PUBLIC INTEREST REVIEW FOR GROUNDWATER APPLICATIONS

TO: Water Rights Section Date 06/11/2015
 FROM: Groundwater Section Phillip I. Marcy / Ivan K. Gall
 SUBJECT: Application G- 18002 Reviewer's Name Supersedes review of Date of Review(s) _____

A. GENERAL INFORMATION: Applicant's Name: William L. and Cindy R. Romans County: Malheur

A1. Applicant(s) seek(s) 3.11 cfs from 2 well(s) in the Malheur Basin, Bully Creek subbasin

18.00S/41.00E-22AC
MALH 711
573
49
3018

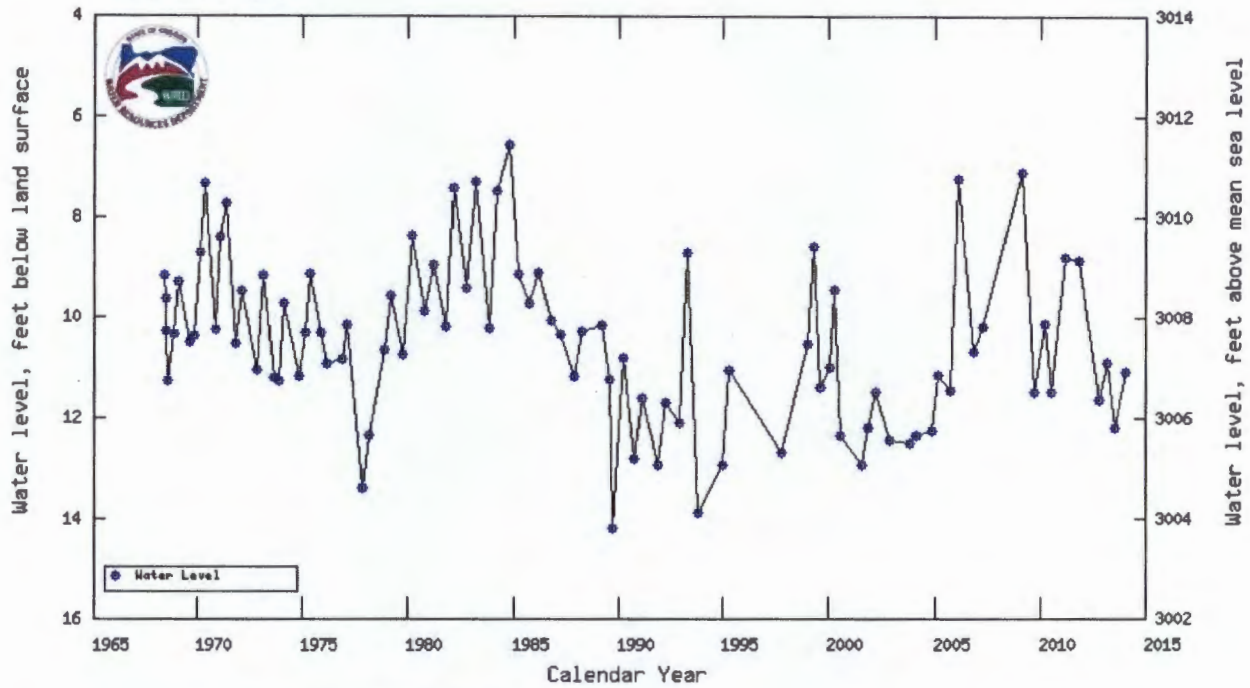
B3. **Groundwater availability remarks:** Groundwater elevation data from nearby State Observation Well 573 (MALH 711) shows fluctuations of less than 7 feet through the past 40 years. This is a shallow well, reported at only 49 feet in depth, and may not represent the deeper aquifer system the applicant is proposing to produce groundwater from. Groundwater levels in the applicant’s well 1 (MALH 723) are very near their original elevation upon completion of the well in 1987 (see attached).

Basis for aquifer confinement evaluation: Well logs for both wells show head elevations significantly higher than the elevations of their respective water-bearing zones. Groundwater elevations in both wells are vastly different than those at nearby MALH 711 (see attached), which likely reflect the shallow alluvial aquifer system in connection with local surface waters with similar head elevations. **The evaluation of aquifer confinement in well 1 (MALH 723) relies on well reconstruction as described in Section D. Without this reconstruction, this well shall not be used for production of groundwater.**
